ECE/TRANS/WP.29/2009/123/Corr.3  
24 December 2009

Revision of the Consolidated Resolution on the Construction of Vehicles (R.E.3)

Corrigendum

Page 14, chapter II, section G, paragraph 3.(d)

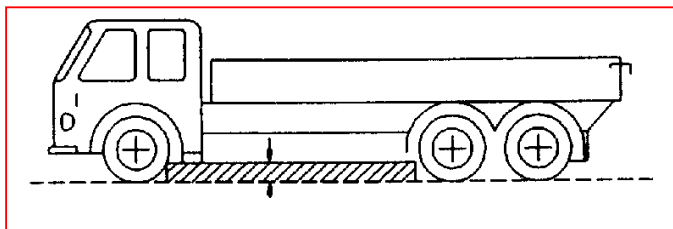
For the existing figure, substitute
